ADDENDUM NO. CC-1

TELEGRAPH DISTRICT
401 BUILDING RENOVATION
LINCOLN, NEBRASKA
DLR GROUP PROJECT NO. 10-16202-00

February 26, 2016

5 ENLARGED RESTROOM PLAN - WOMEN 104
SCALE: 1/4" = 1'-0"

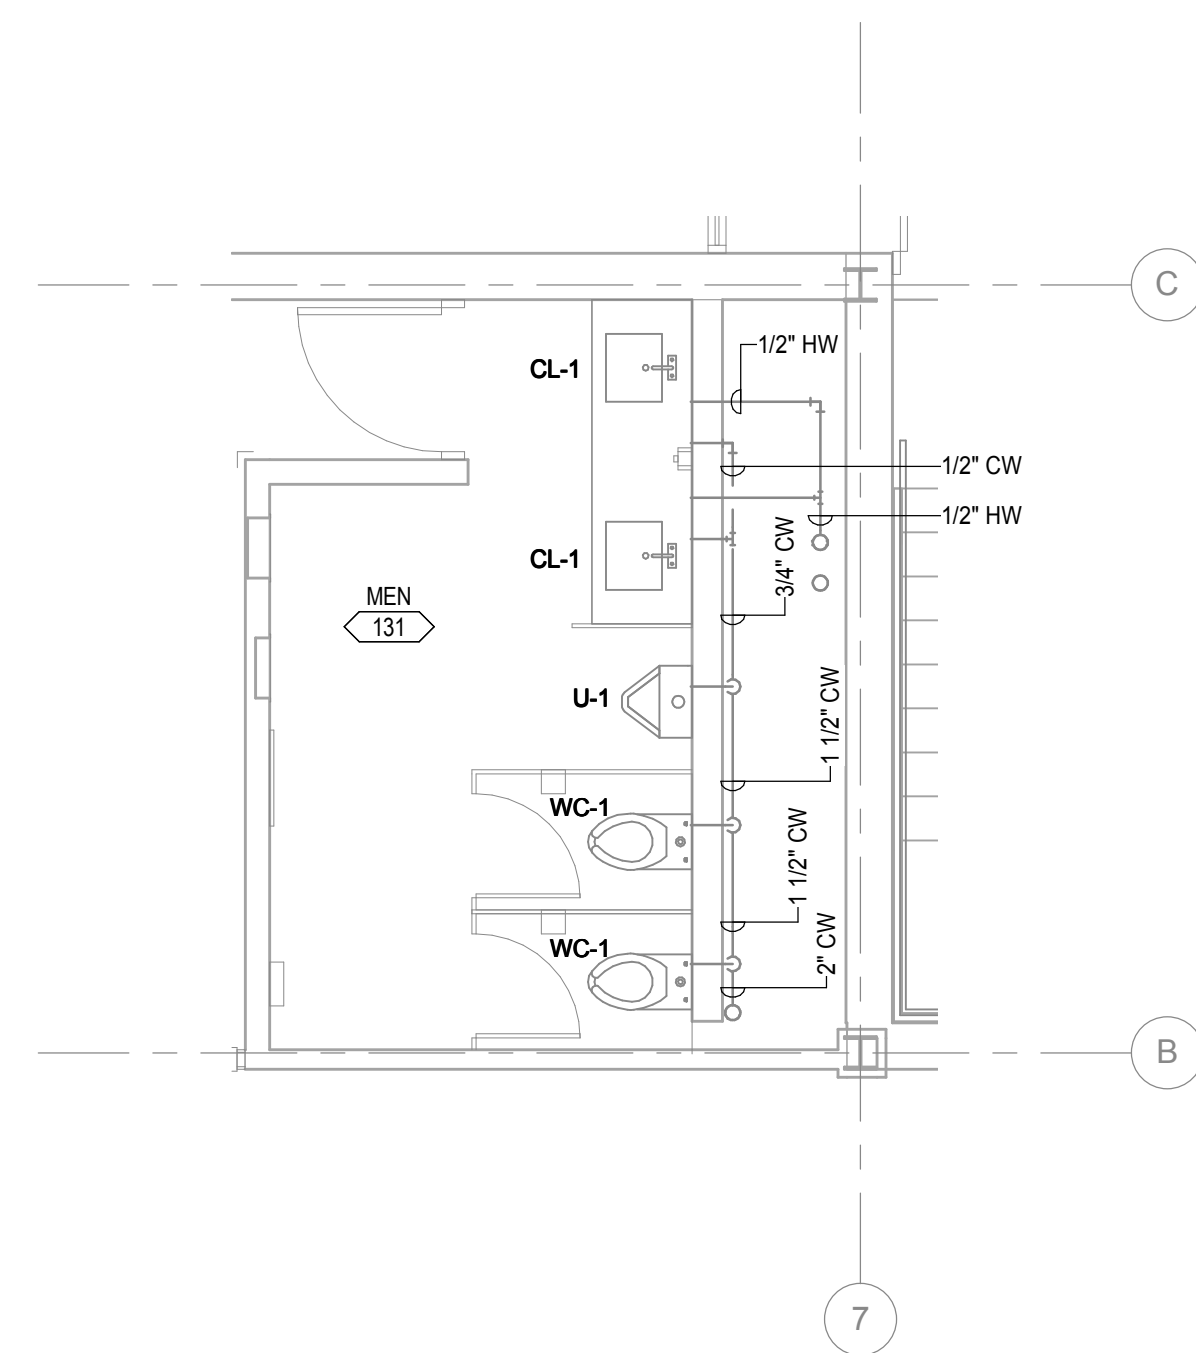
ITEM NO. 13 DRAWING P4.1 ENLARGED PLUMBING PLANS

- A. Revise the drawing as shown in the attachment P4.1 for modifications to the plumbing plan.
- B. Additional information has been added to clarify balancing valve locations and pipe sizing.

P4.2
10-16202-00
02/26/2016
Revised
Addendum #1 03/11/16

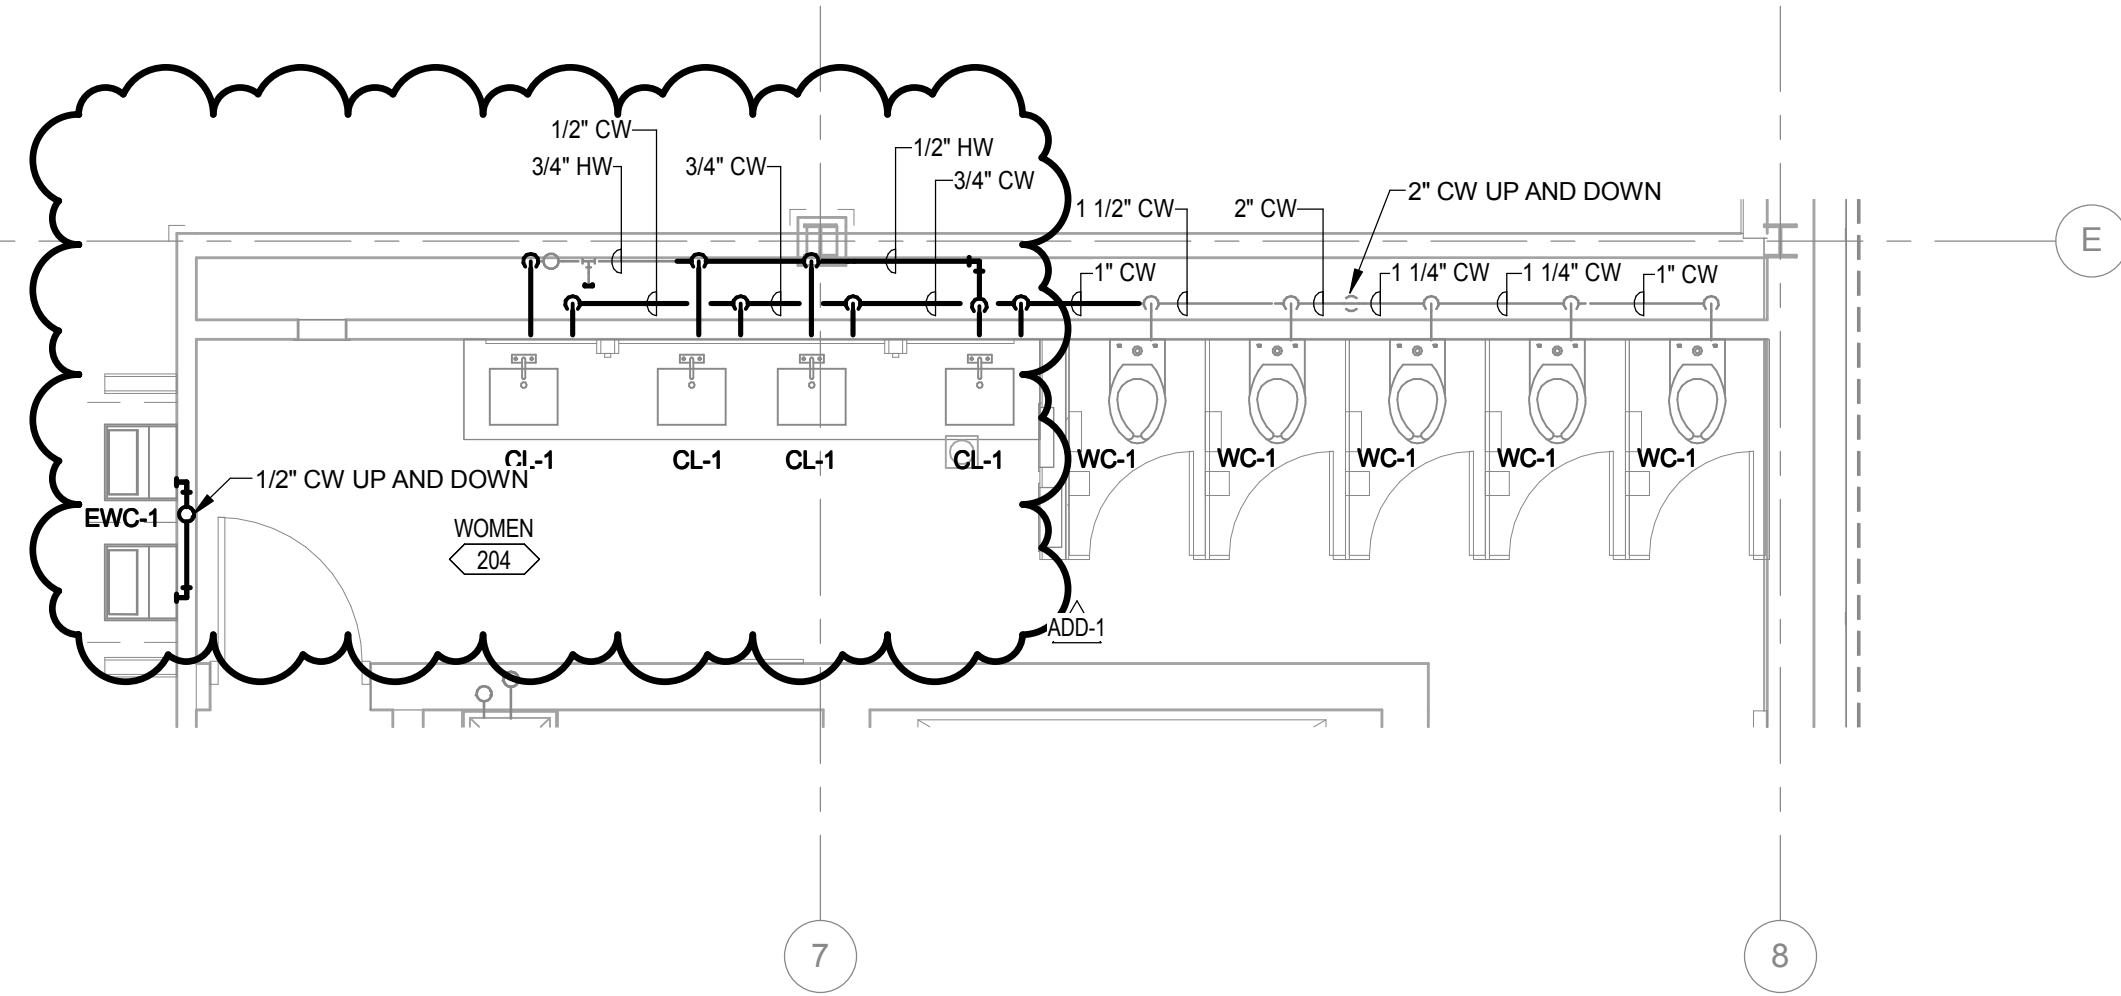
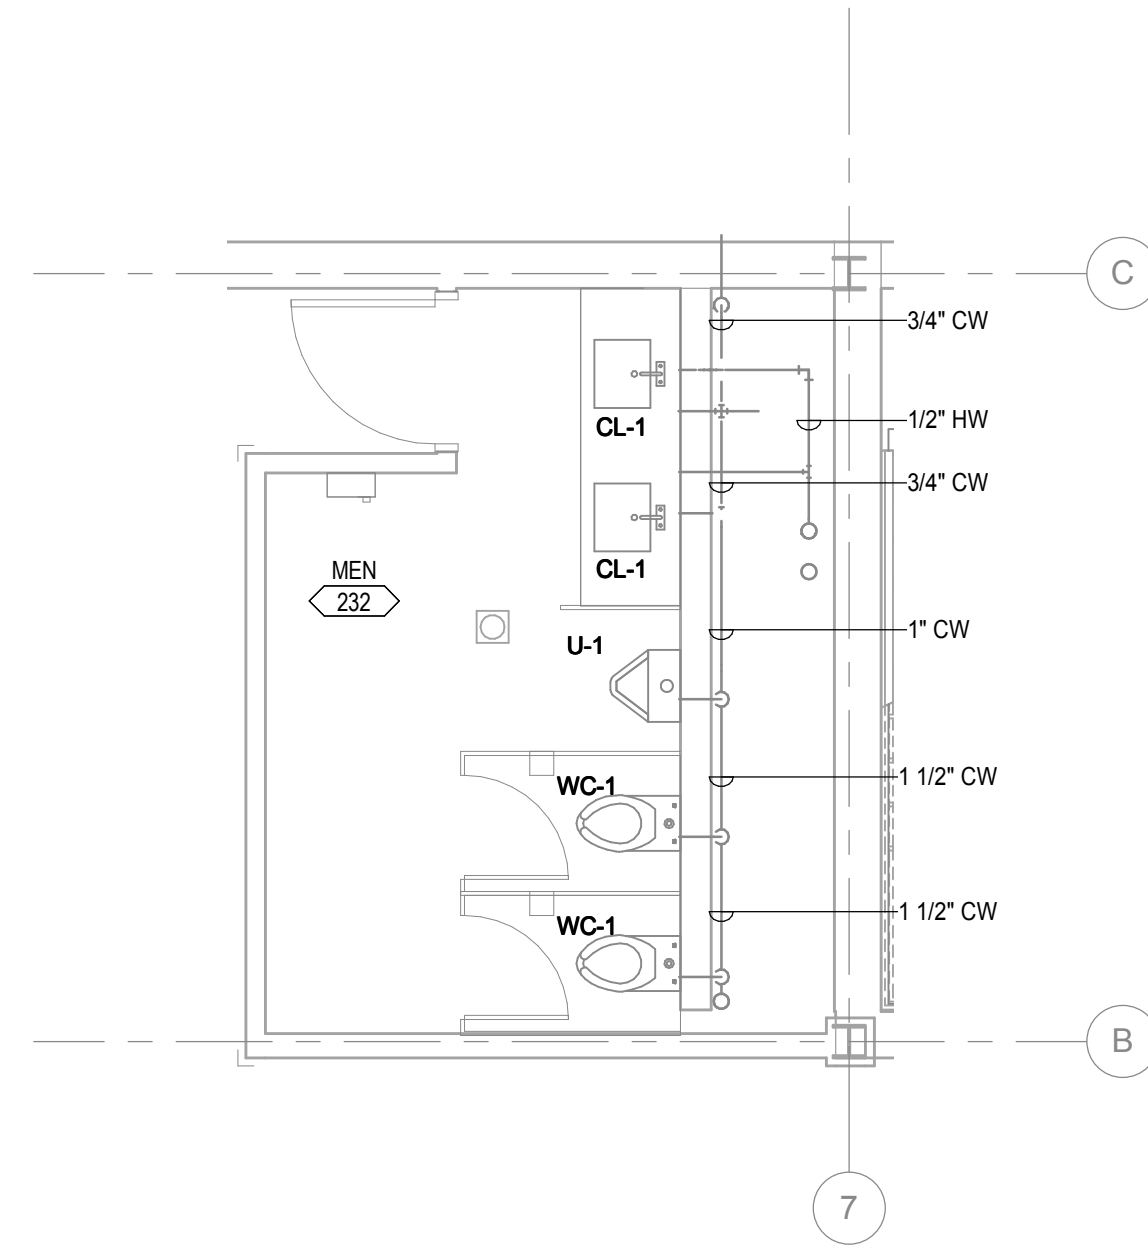
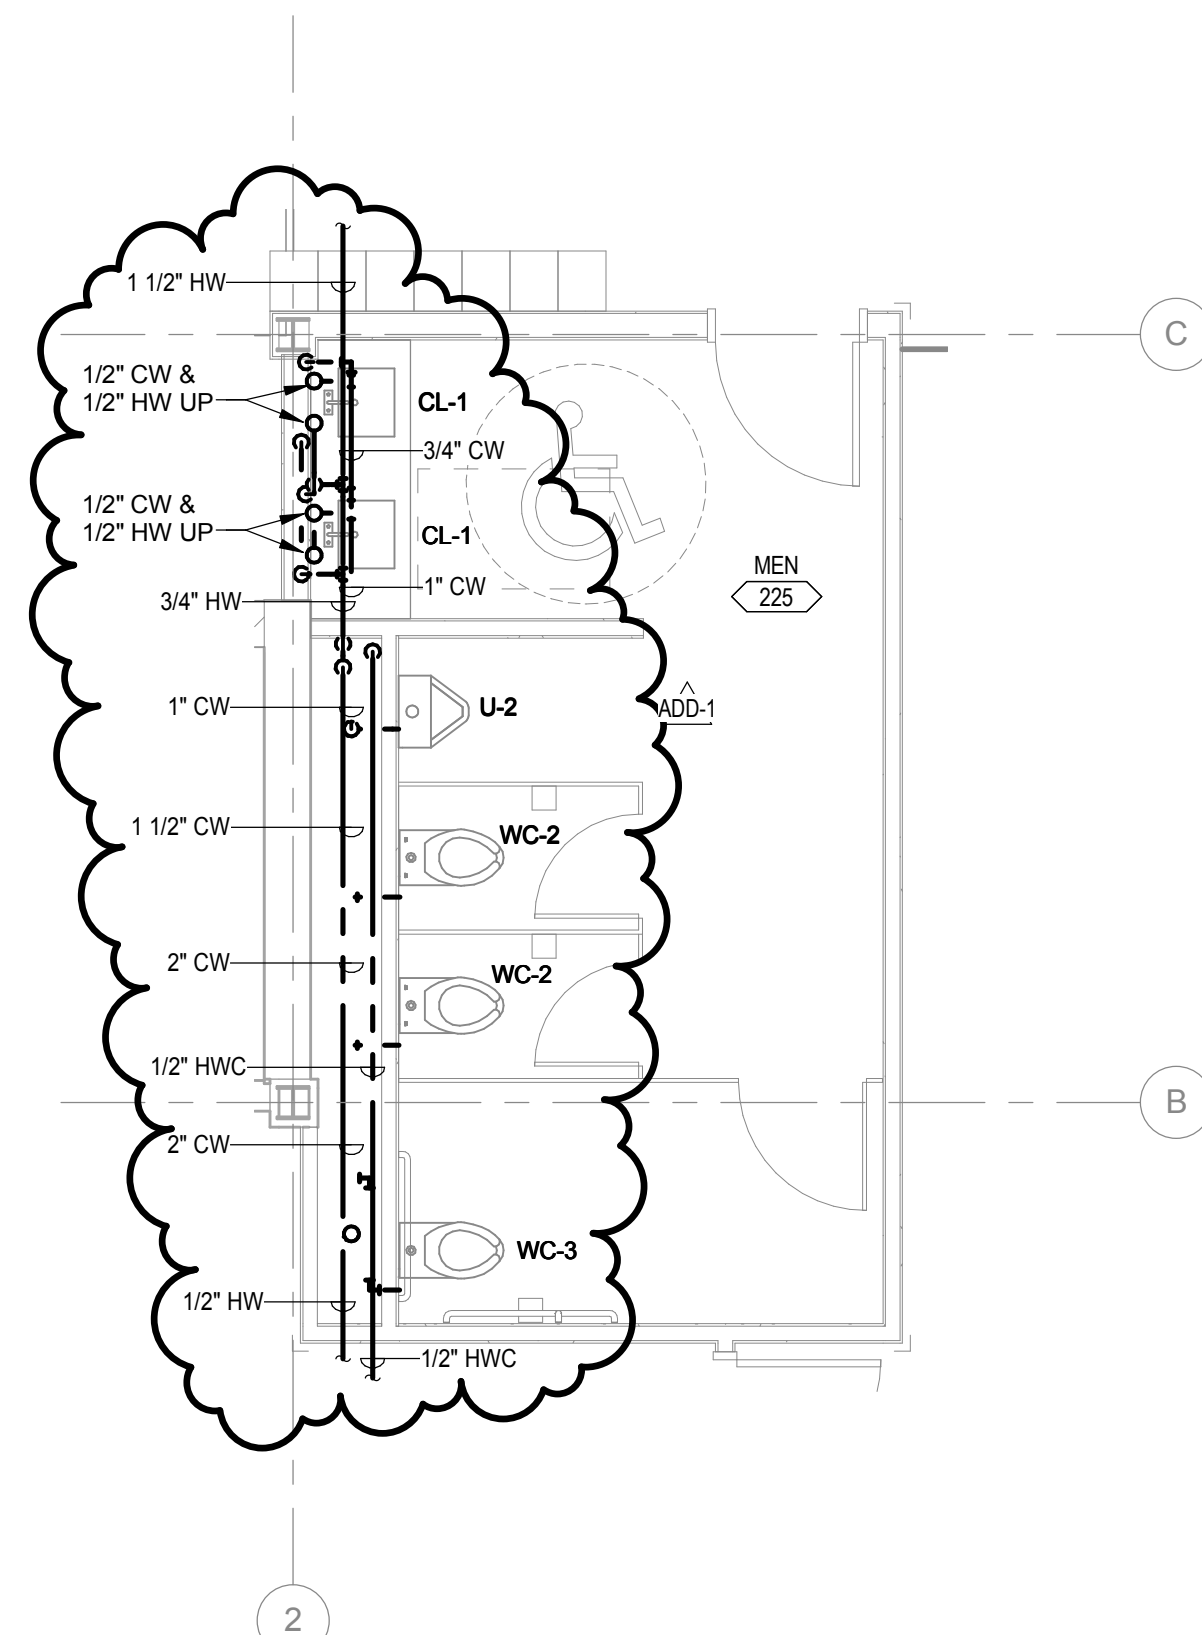
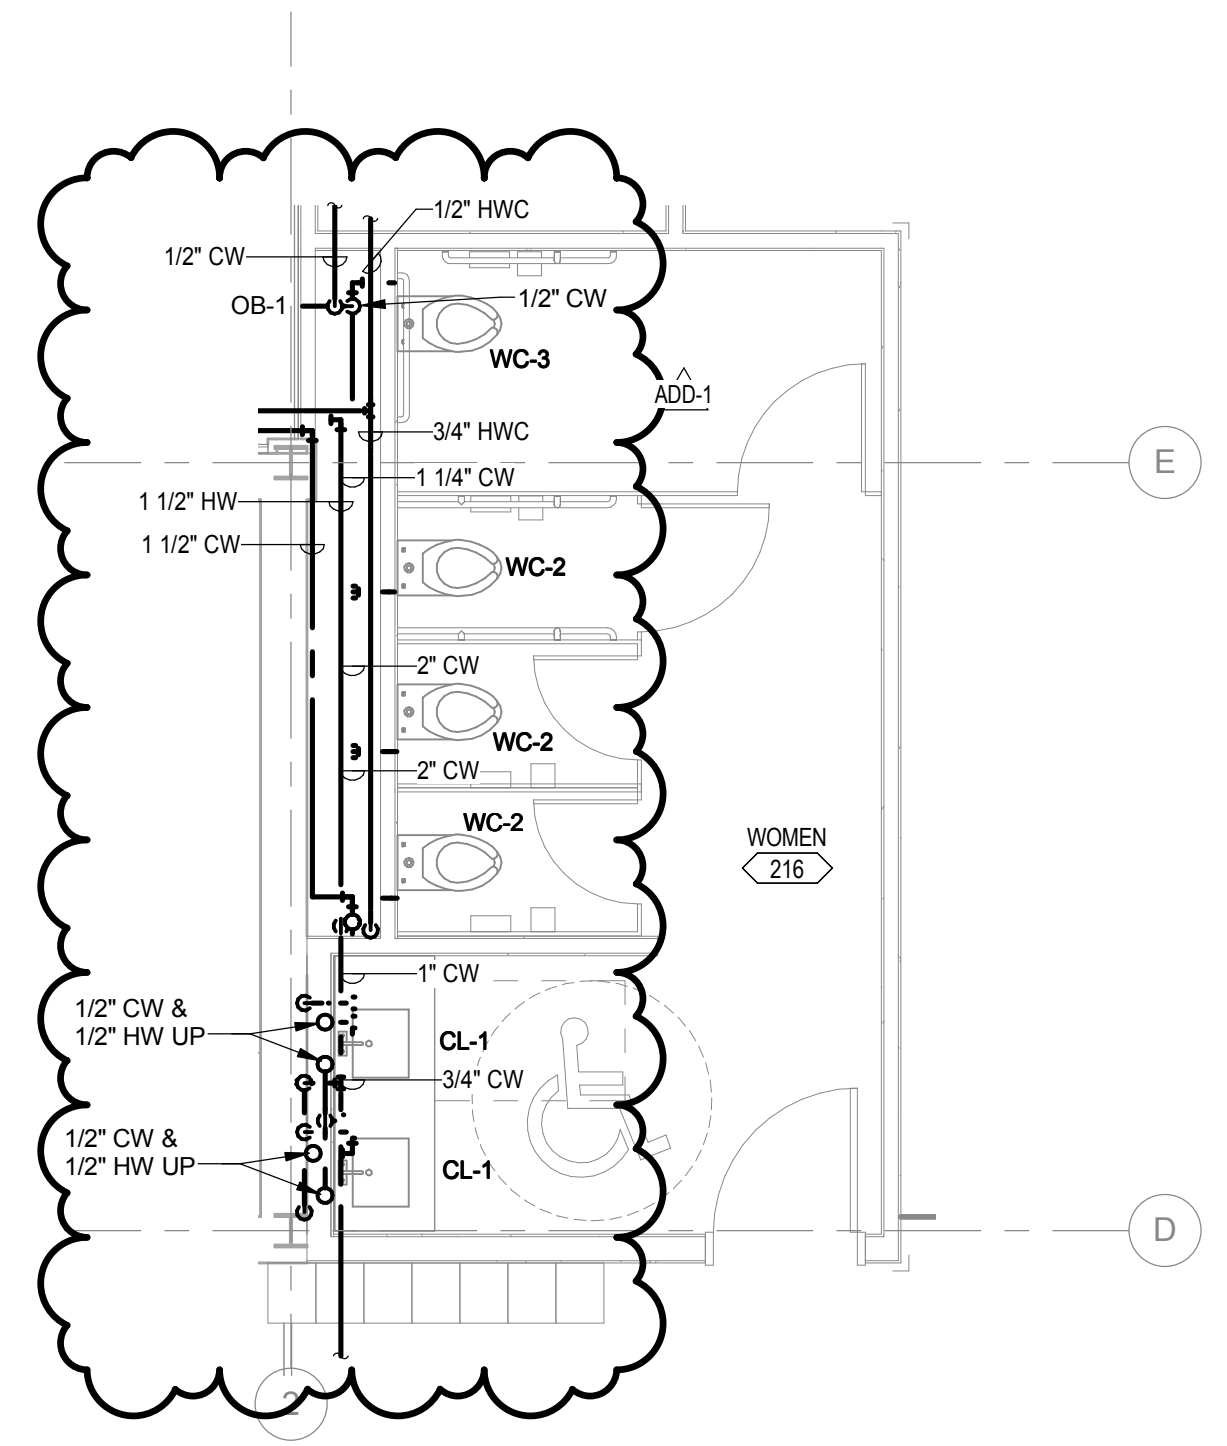
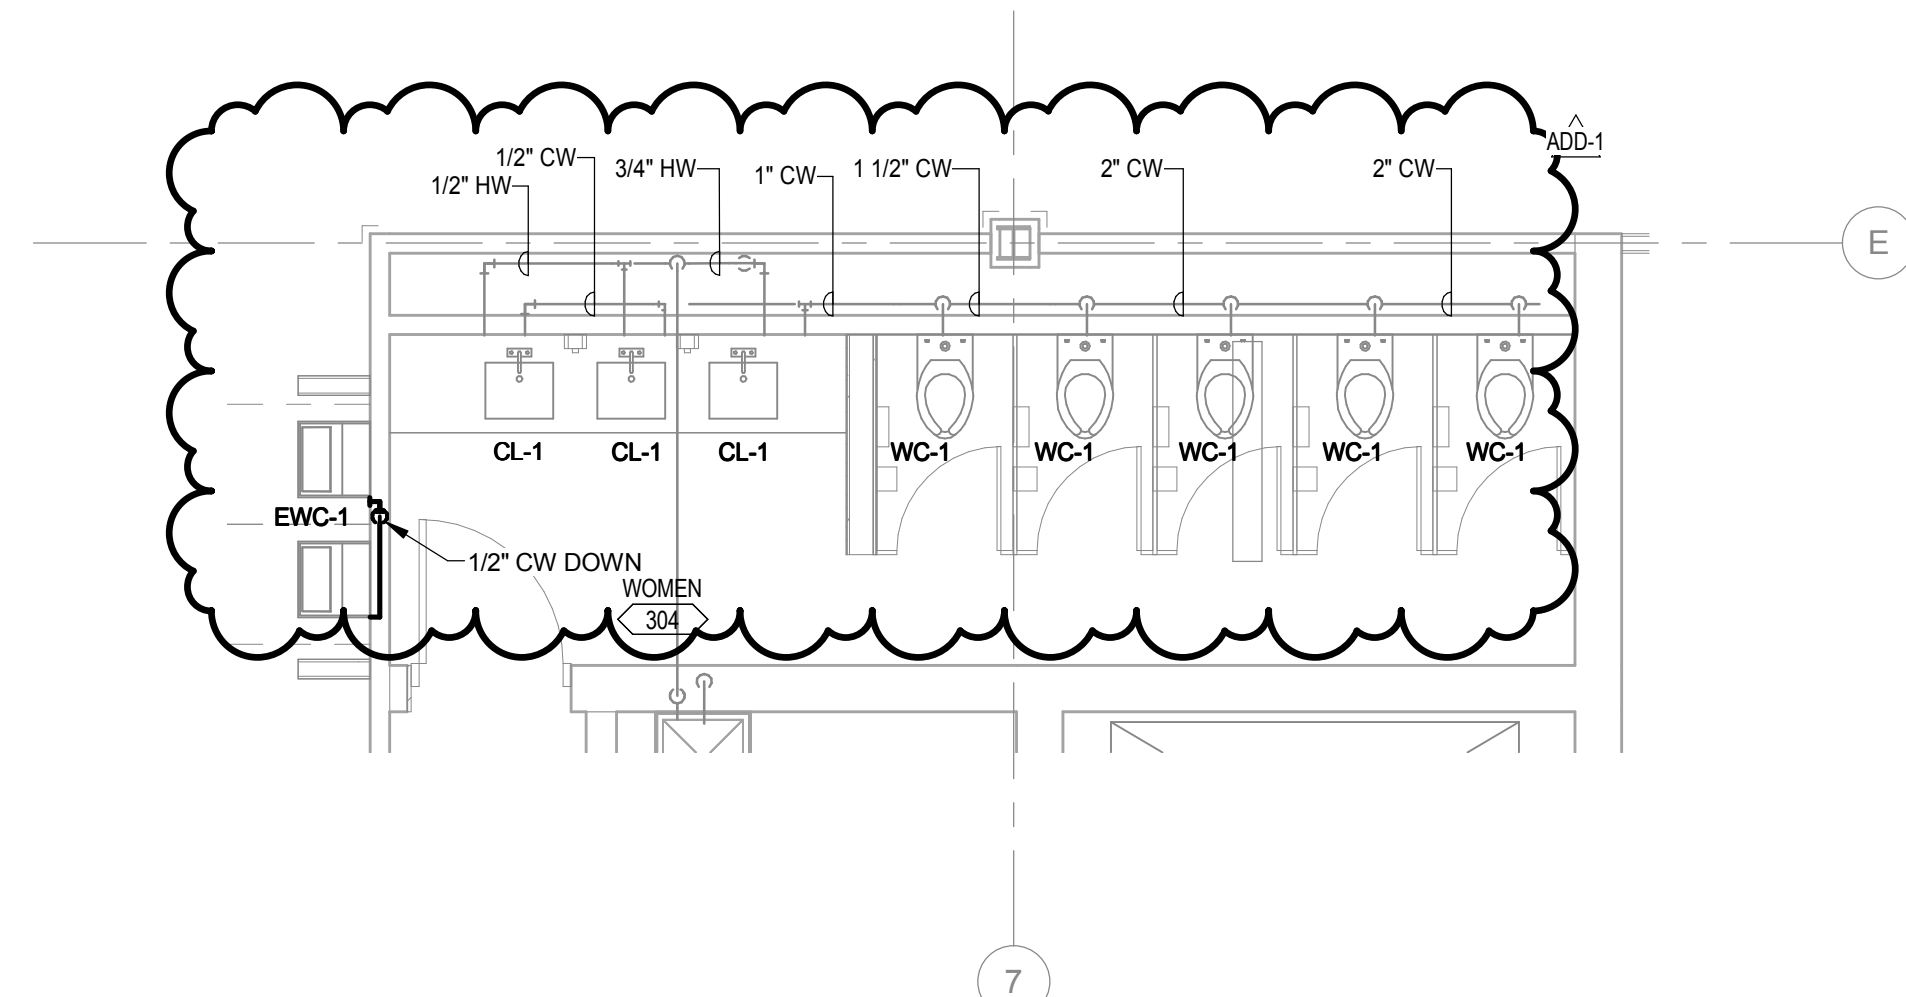
ITEM NO. 14 DRAWING P4.2 ENLARGED PLUMBING PLANS

- A. Revise the drawing as shown in the attachment P4.2 for modifications to the plumbing plan.
- B. Additional information has been added to clarify pipe sizing and routing.
